SUBJECT: COMANCHE PEAK STEAM ELECTRIC STATION, UNITS 1 AND 2 - AMENDMENT
NOS. 21 AND 7 TO FACILITY OPERATING LICENSE NOS. NPF-87 AND NPF-89
(TAC NOS. M86654 AND M86655)

ATTACHMENT TO LICENSE AMENDMENT NOS. 21 AND 7
FACILITY OPERATING LICENSE NOS. NPF-87 AND NPF-89
DOCKET NOS. 50-445 AND 50-446

SAFETY EVALUATION BY THE OFFICE OF NUCLEAR REACTOR REGULATION

FIGURE 2.1-1a

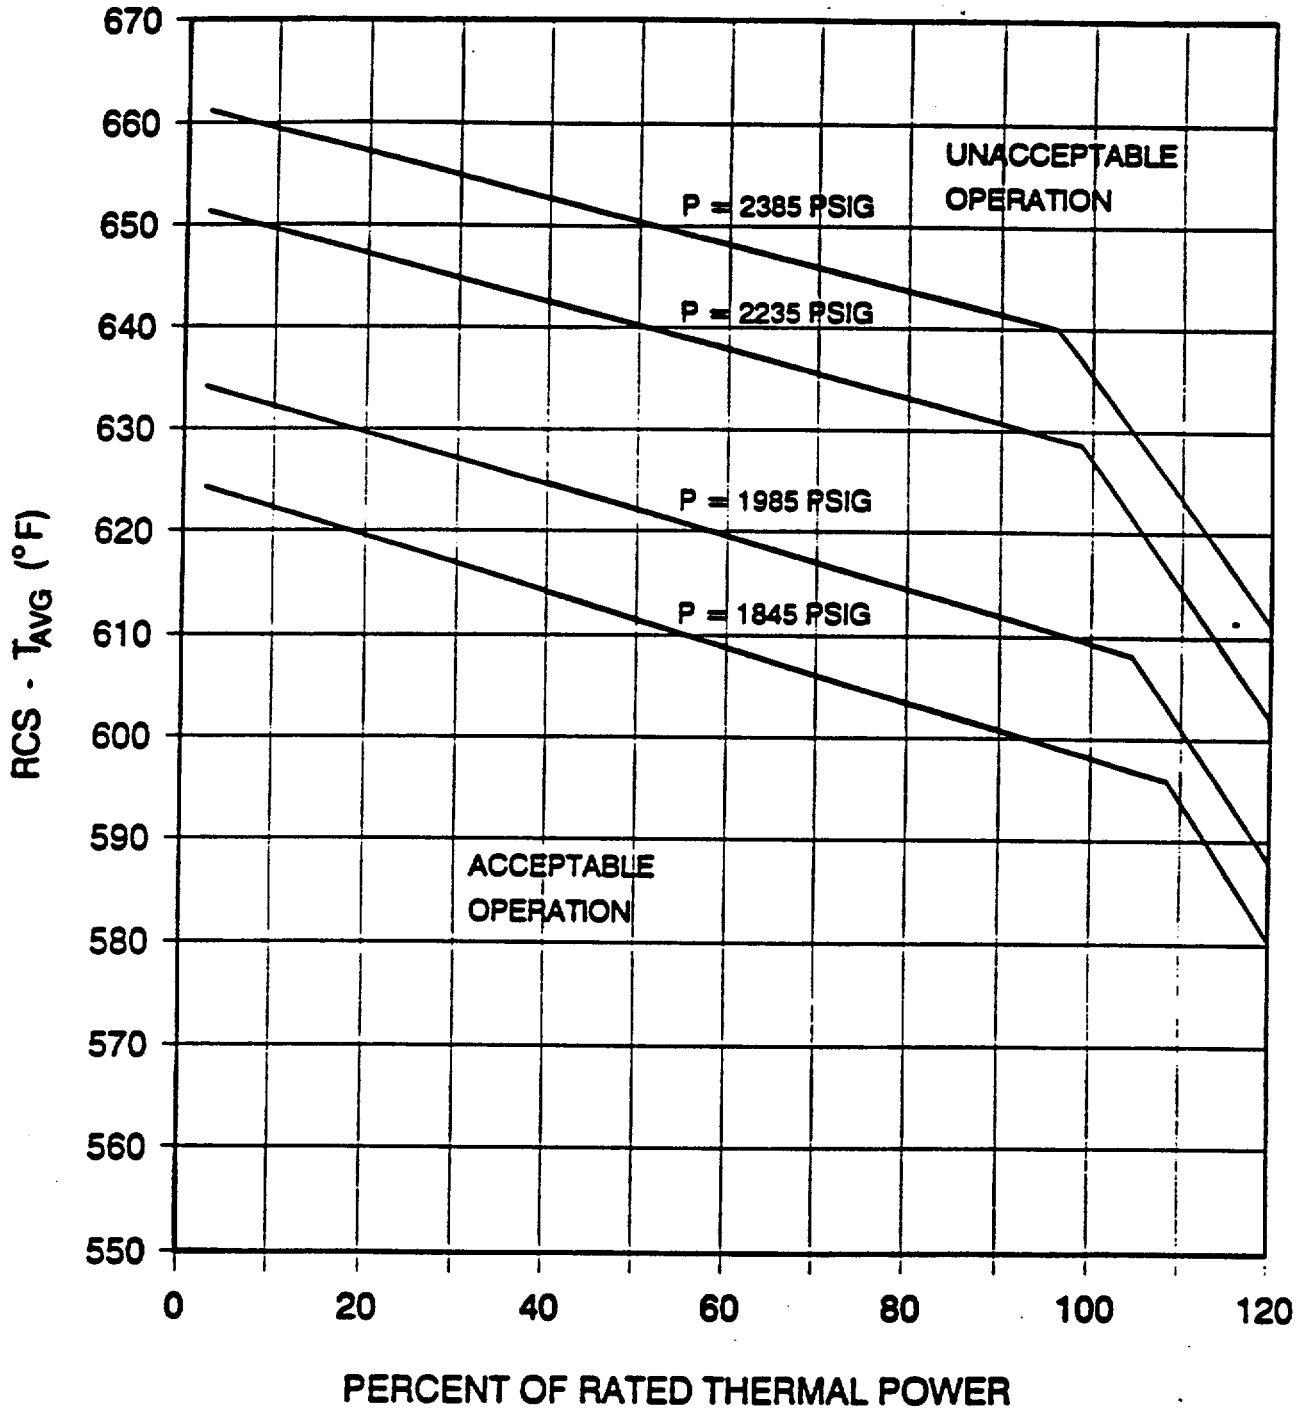
The core safety limits for CPSES Unit 1, Cycle 4 (TS 2.1, Figure 2.2-1a) have been determined using the NRC approved TU Electric methodologies for determining core safety limits, an increase in the assumed RCS TDF rate, an increase in the minimum assumed pressurizer pressure, and a safety analysis DNBR based on the NRC approved TUE-1 DNB correlation.

(1) Figure 2.1-1a, page 2-2, Unit 1 reactor core safety limits

TS Figure 2.1-1a was revised because of the use of the new TU Electric methodologies for reload analyses, the increase in the TDF rate, and the increase of the minimum pressurizer pressure.

We find this figure to be acceptable as discussed in the evaluation in Section 3.0.
